NON-CONCURRENCE PROCESS COVER PAGE

NCP-2016-021
11/23/16 NCP PM

TITLE OF SUBJECT DOCUMENT
IPs 71111.17T and 71111.21M

ML16147A416
ML16238A320

Figure 1 - Direct Impact to the Licensee's Fee and Regional Budget

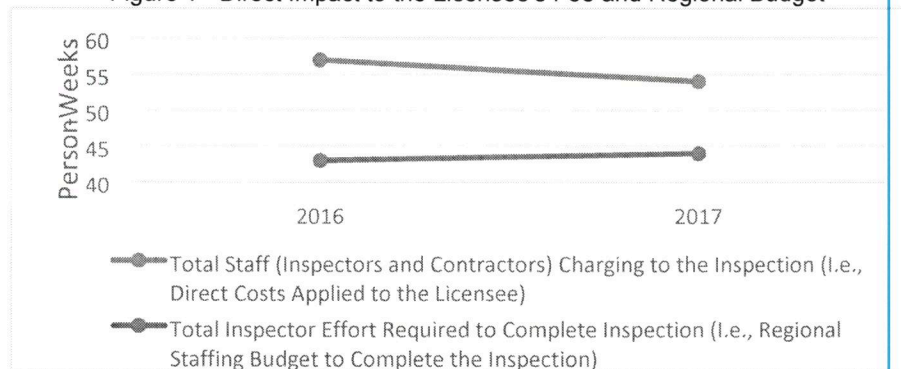
Impact to Direct Costs (i.e., fees) Assessed to Licensees

- As a result of the reduced overall footprint (i.e., reducing total man-weeks from 57 to 54 man-weeks, see Table 1), the direct costs associated with **fees assessed to the licensees is expected to be reduced.**

Impact to Inspection Budget to the Regional Offices

- Though the overall footprint is expected to be reduced by removing two-weeks of contractor support, the **impact to the regional staffing budget is expected to increase by approximately 0.2 FTE.** This increase in staffing requirements is exasperated by the reduction in total FTE as imposed by Project AIM (i.e., fewer inspectors will be required to perform more work than is currently being performed).
